NAVSHIPS 0967-063-2010

RADIO RECEIVER R-390A/URR

T- 5 , NAVSHIPS 0967-063-2015 Date 18 February 1972

INTERIM CHANGE T- 5 TO NAVSHIPS 0967-063-2010, TM for Radio Set R-390A/URR.

Figure 5-13. Schematic Diagram (Sheet 2 of 4)

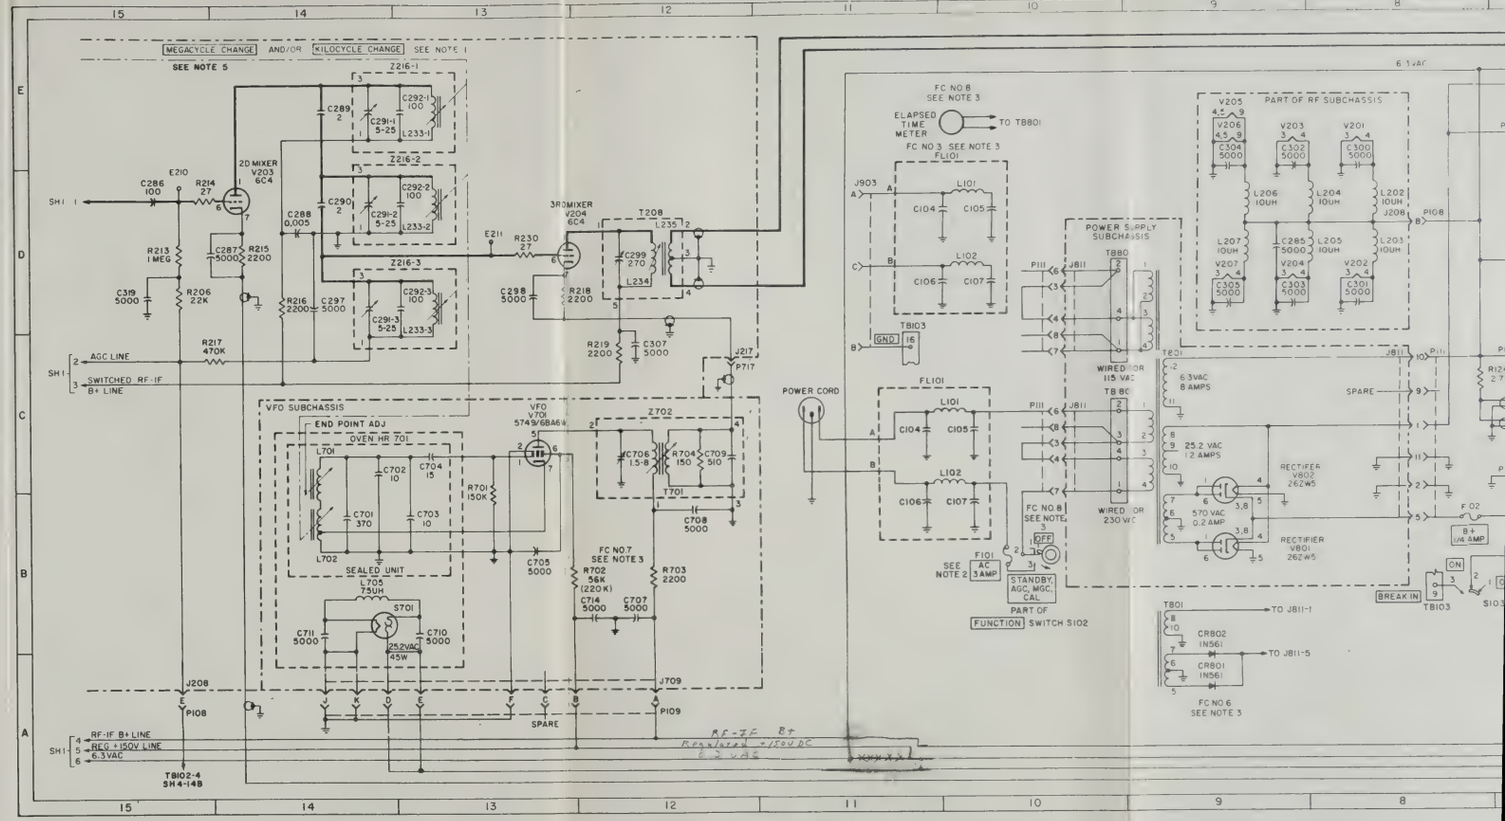
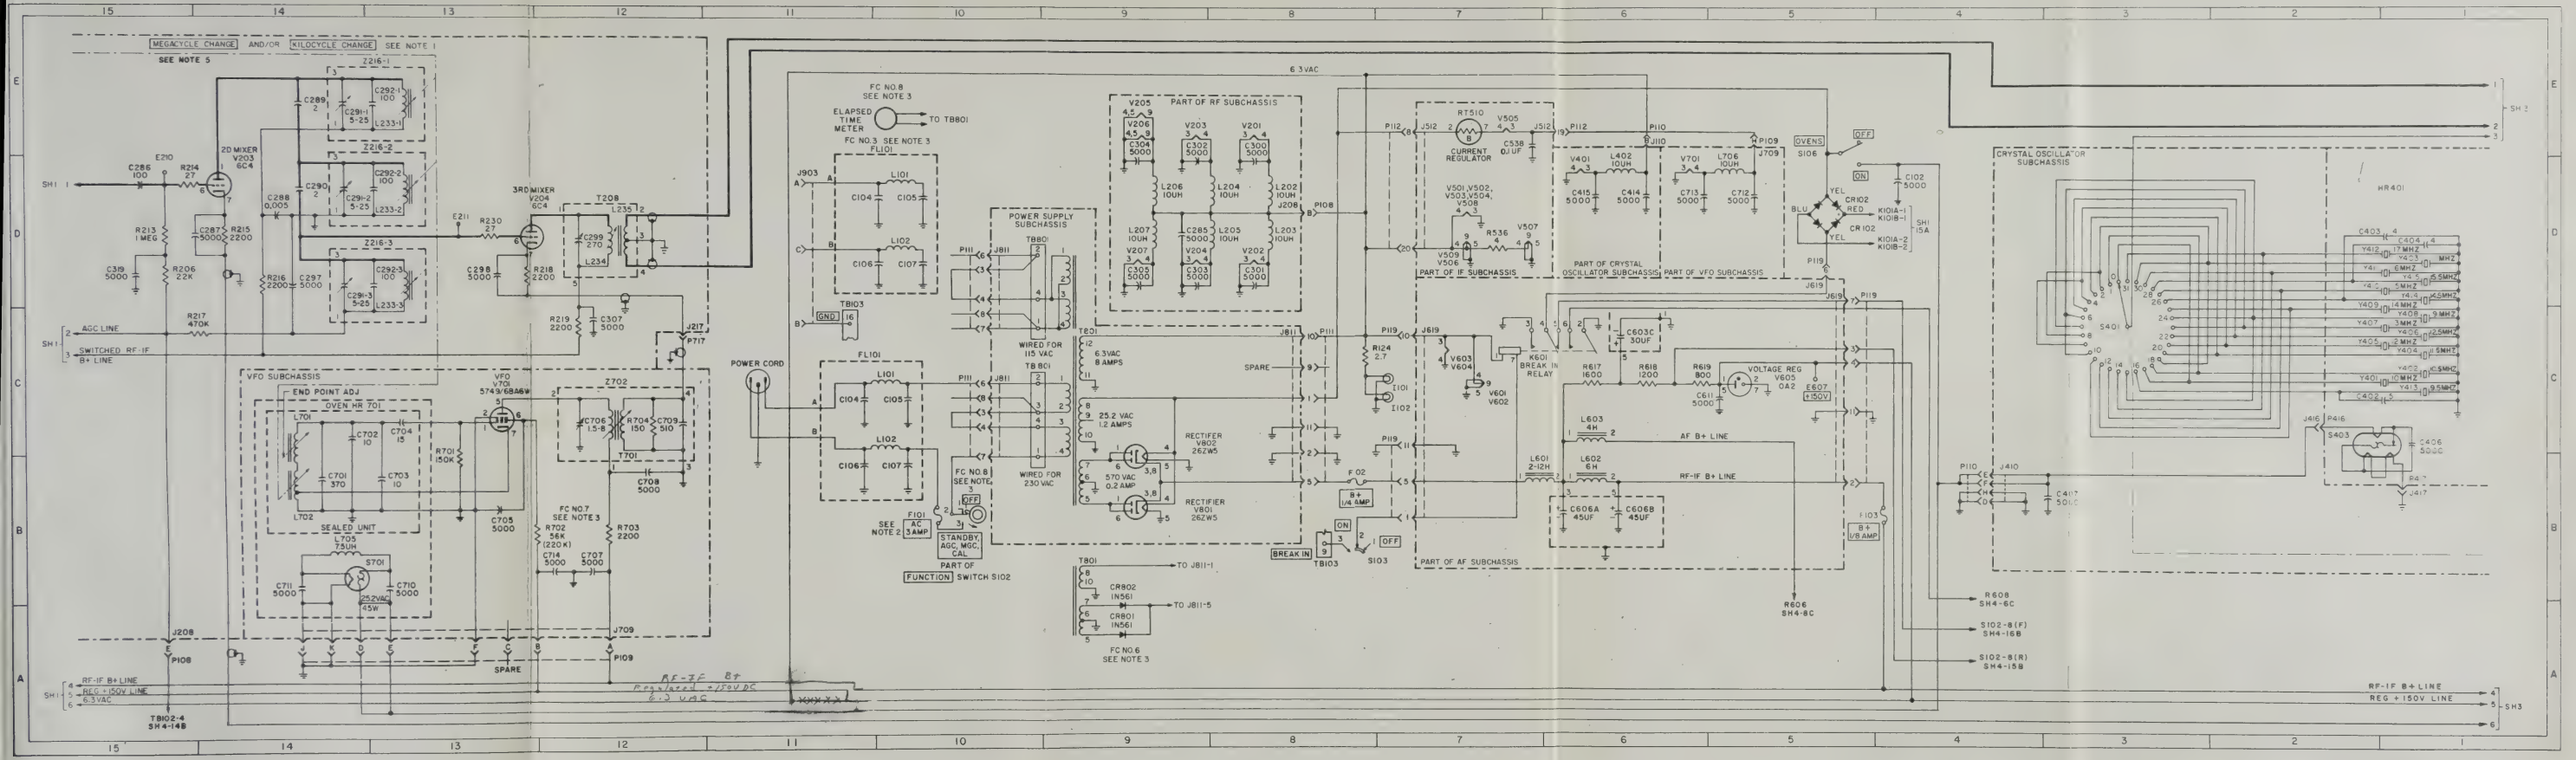
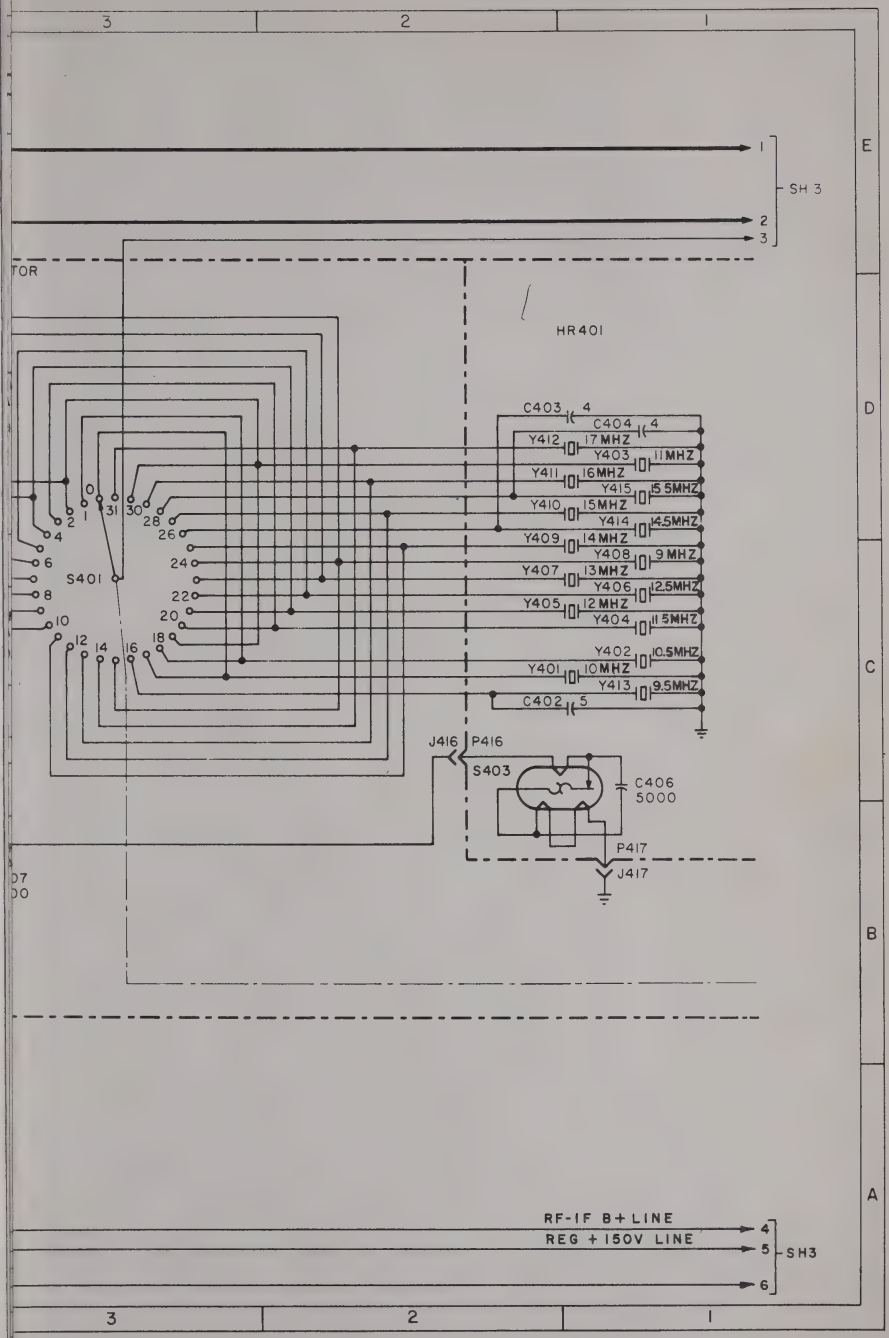
1. Section 5, page 5-41, figure 5-13 (Sheet 2 of 4) in the 11A zone, correct the "RF-IF B+", the "Regulated +150 VDC" and the "6.3 VAC" as shown in figure 1.

Figure 5-13. Schematic Diagram
(Sheet 3 of 4)

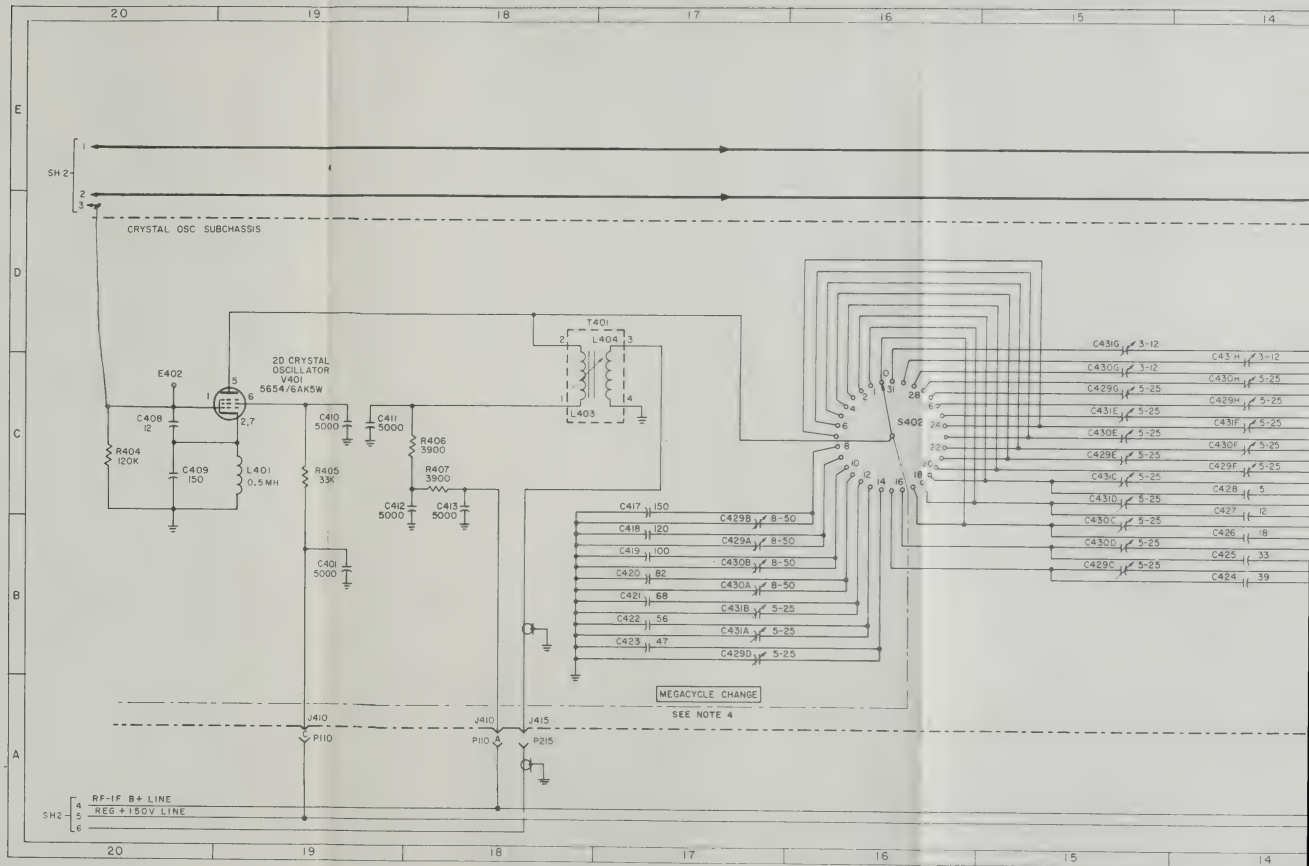
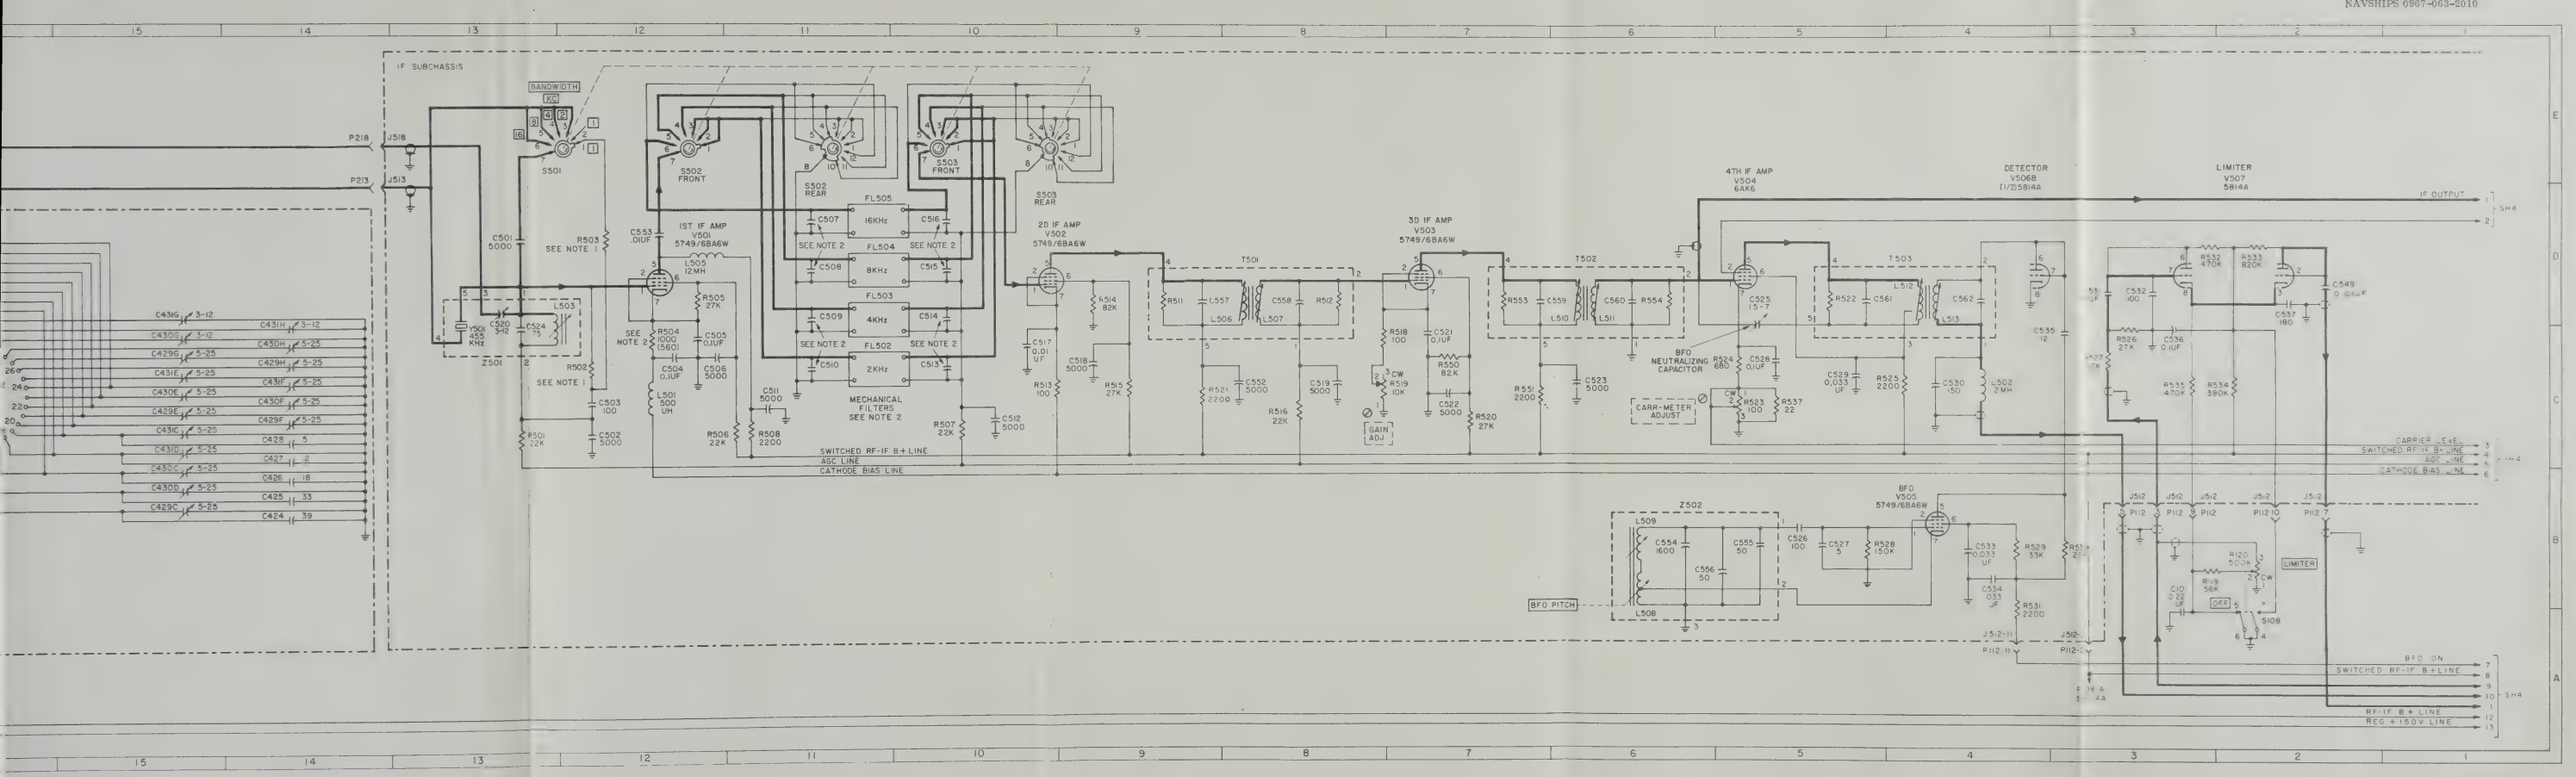
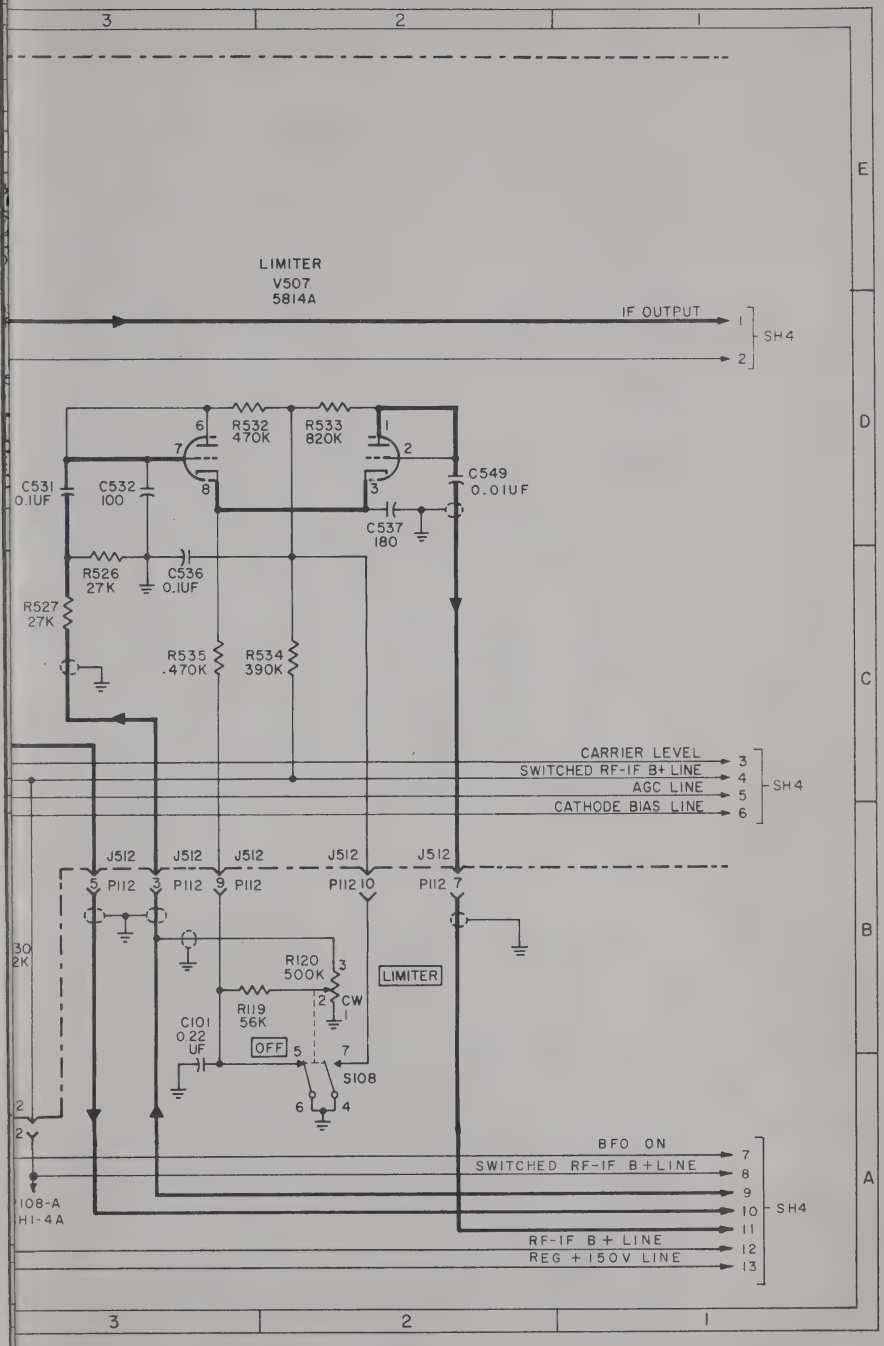
1. Section 5, page 5-45, figure 5-13 (Sheet 3 of 4) in the 20C and 20D zone. Draw a vertical line connecting the junction of R-404, C-408, and E-402 to line #3 as shown in figure 1.
